# UNITED STATES PATENT AND TRADEMARK OFFICE

10/538,968

<b>Office Action Summary</b>	<b>Application No.</b> 10/538,968	<b>Applicant(s)</b> VELICANIN, MENSUR	
	<b>Examiner</b> KRISTINA R. FULTON	<b>Art Unit</b> 3673

## **DETAILED ACTION**

**Fig.11**

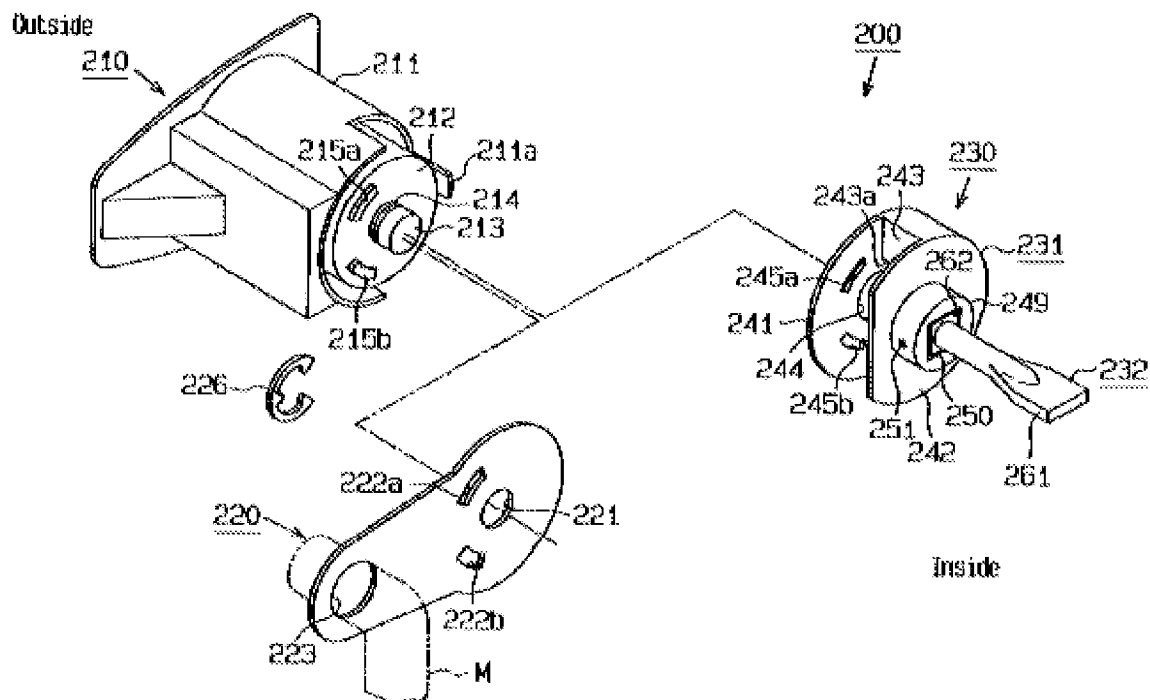
6. Regarding claim 1, Katagiri shows an actuating device for a lock in a door or hatch of a motor vehicle (column 1, line 8), with a lock cylinder (200), which has a lock (column 9, lines 57-58) located a certain axial distance away and a one-piece shaft (232) extending between the lock cylinder and the lock; which shaft transmits a force to the lock when the lock cylinder is rotated; the shaft is flexible in an axial direction of the shaft to compensate for a radial offset between the axis of the lock cylinder and the lock (column 12, lines 15-25) and wherein a driver (261) for actuating the lock and/or a connection (230) for the lock cylinder is formed integrally on the shaft. See the Katagiri device below.

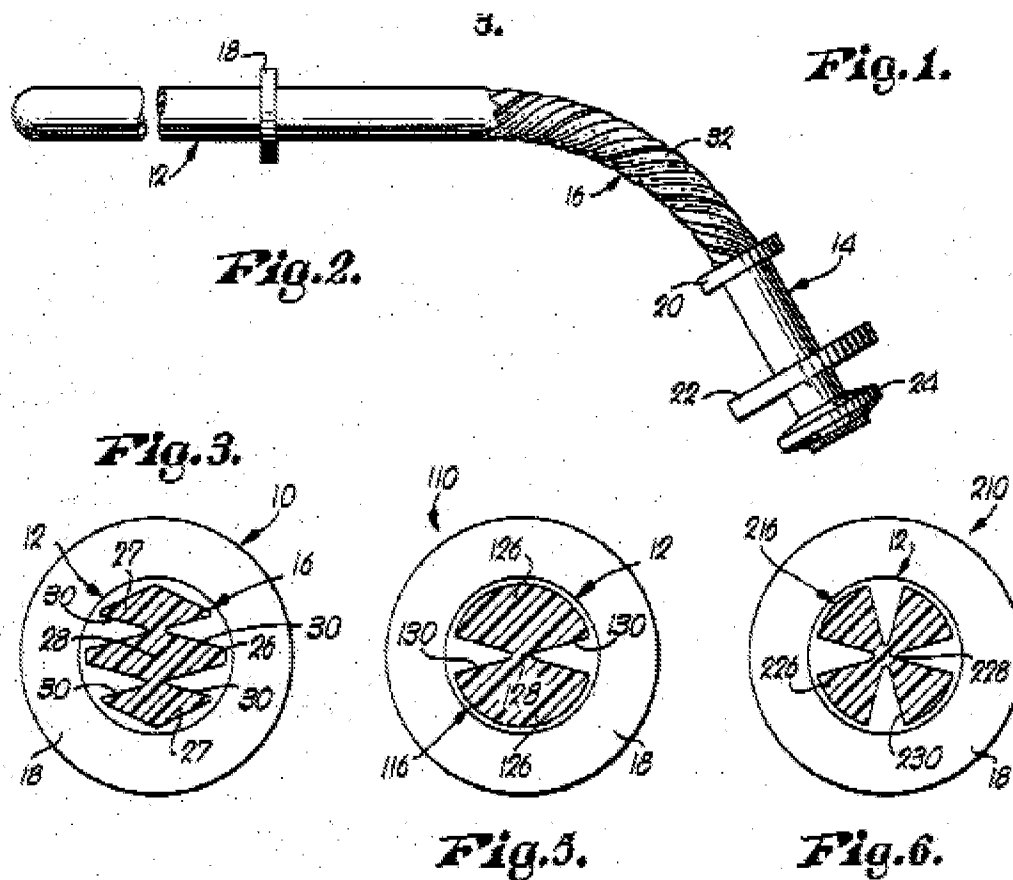
7. Although Katagiri shows applicant's basic inventive concept of an actuation device for a lock in a motor vehicle, Katagiri fails to show a shaft which submits a torque having the claimed notches, but Brahler shows this to be well known in the art. Brahler shows a flexible drive shaft (10), usable in any application (column 4, lines 40-48) for transmitting torque (column 4, line 31) wherein the one-piece shaft is made of flexible material (see claim 1) and has a family of notches (30) extending transversely to the axis of the shaft; the notches are recessed in pairs (see figure 3) into the shaft from diametrically opposing sides, the notches each having two flanks (each side of the notch); wherein when the shaft is stretched out straight, the two flanks of the notches are "essentially" parallel to each other and extend radially with respect to the axis of the

shaft; wherein the notch pairs leave a web (28) in the shaft between the flanks the web is located on the axis of the shaft and extends essentially across the entire diameter of the shaft; the web produces flex points(see bending at 32 in figure 2), at which, when bending load is exerted on the shaft, the two flanks of the notch pairs can swing toward or away from each other (the flanks can bend toward or away from each other depending on the bending of the shaft); wherein intermediate axial pieces (26, 27), extending in the axial direction of the shaft and with the full cross section of the shaft , remain between successive pairs of diametrically opposing notches. It would have been obvious to one of ordinary skill in the art to replace the shaft portion of Katagiri using the flexible shaft of Brahler to provide enhanced flexibility. Replacing one flexible shaft with another flexible shaft is considered to be within the level of ordinary skill in the art. See the Brahler device below.
